**PLANNED UNIT DEVELOPMENT &  
SUBDIVISION STAFF REPORT****Date: March 17, 2005**

<b><u>DEVELOPMENT NAME</u></b>	Forrest Cove Subdivision
<b><u>SUBDIVISION NAME</u></b>	Forrest Cove Subdivision
<b><u>LOCATION</u></b>	South side of Moffett Road at the South terminus of Northview Drive
<b><u>CITY COUNCIL DISTRICT</u></b>	District 7
<b><u>PRESENT ZONING</u></b>	R-1, Single-Family Residential
<b><u>AREA OF PROPERTY</u></b>	66.8± Acres / 221 Lots
<b><u>CONTEMPLATED USE</u></b>	221 lot single-family residential subdivision with reduced lot widths, lot sizes and building setbacks, as well as increased site coverage.
<b><u>TIME SCHEDULE FOR DEVELOPMENT</u></b>	Immediate
<b><u>ENGINEERING COMMENTS</u></b>	Must comply with all stormwater and flood control ordinances. Any work performed in the right of way will require a right of way permit.
<b><u>TRAFFIC ENGINEERING COMMENTS</u></b>	Driveway number, sizes, location and design to be approved by Traffic Engineering and conform to AASHTO standards. Install traffic calming measures in the subdivision

# SITE PLAN

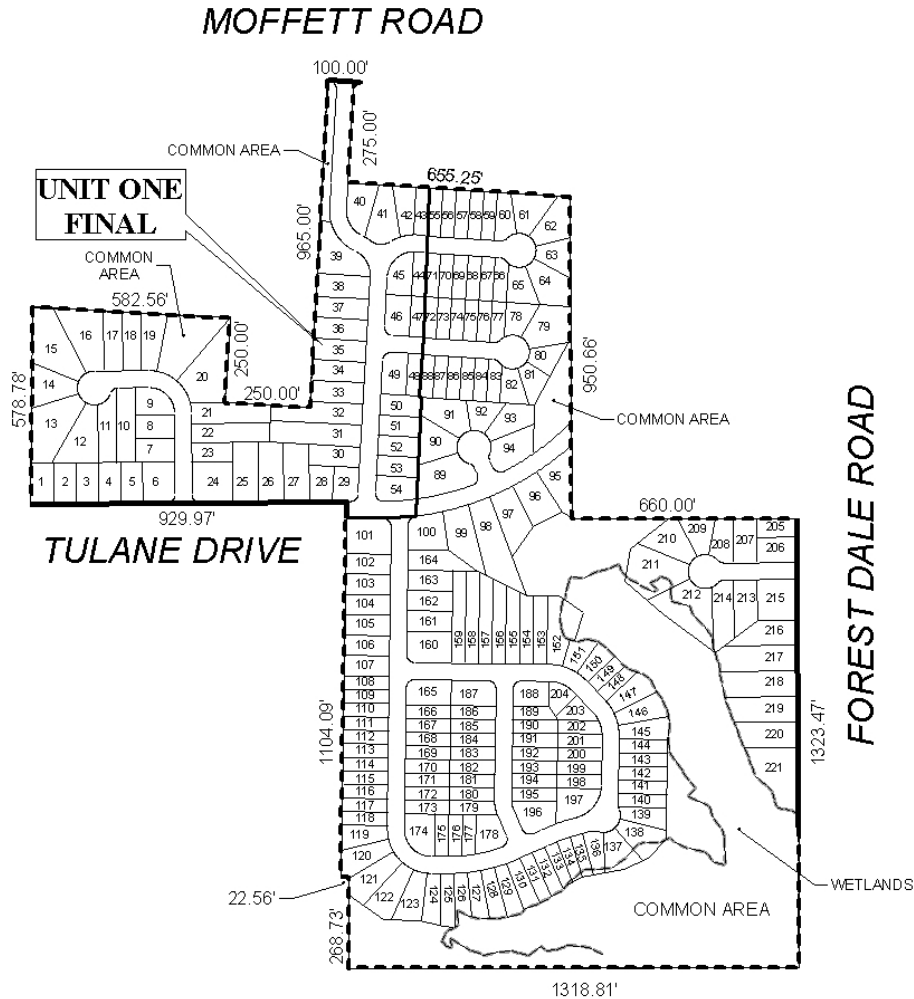
In terms of access and roads there is some concern. First, Tulane from Forest Cove Drive eastward is essentially a driveway, thus the road in this area must be improved to city standards. Furthermore, the provision of a cul de sac at the East end of Tulane Drive, should be required. An additional consideration regarding access is that no more than 100 new lots should be developed with out providing a second point of access; i.e., the new street(s) connecting Moffett Road and Tulane Drive must be built prior to recording the 101<sup>st</sup> lot.

The site contains wetlands thus the area could be considered environmentally sensitive, therefore, the approval of all applicable federal, state and local agencies would be required. Regarding the common areas, a note should be placed on the final plat stating that the maintenance of the common areas shall be responsibility of the property owners.

**Planned Unit Development:** Based upon the preceding, this application is recommended for approval subject to the following conditions: 1) construction of Tulane Drive to city standards; 2) the provision of a cul de sac at the East end of Tulane Drive; 3) that no more than 100 lots be recorded with out providing a second point of access (connection between Moffett Road and Tulane Drive); 4) the obtaining of all applicable federal, state and local approvals; 5) certification that the stormwater detention

**Subdivision:** With modifications, and a waiver of Section V.D.2., the plat will meet the minimum requirements of the Subdivision Regulations and is recommended for Tentative Approval subject to the following conditions: 1) construction of Tulane Drive to city standards; 2) the provision of a cul de sac at the East end of Tulane Drive; 3) that no more than 100 lots be recorded with out providing a second point of access (connection between Moffett Road and Tulane Drive); 4) the obtaining of all applicable federal, state and local approvals; 5) certification that the stormwater detention system will accommodate the additional site coverage; 6) full compliance with all municipal codes and ordinances; and 7) placement of a note on the final plat stating that the maintenance of all common areas shall be the responsibility of the property owners.

## TYPICAL LOT DETAIL FOR SETBACKS

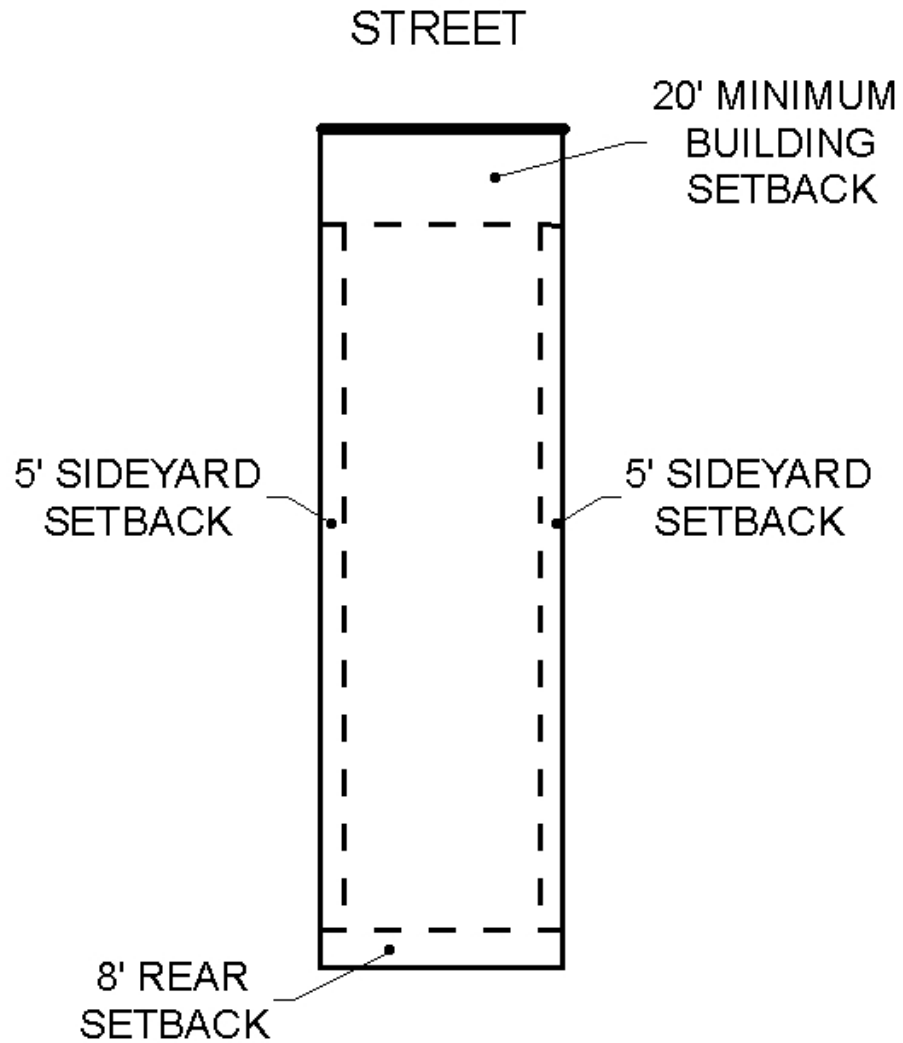
The applicant still proposes reduced lot widths and lot sizes. In terms of the request for reduced setbacks, the applicant proposes a 20-foot front yard setback, and five-foot side yard setbacks. This would provide a minimum of 10-feet between homes and are typical side yards for garden homes in a residential PUD and these minimum setbacks should be illustrated on the final plat. The applicant is also requesting 47.5% site coverage, which again is a typical request for a residential PUD subject to the certification of adequate capacity for the stormwater detention system.
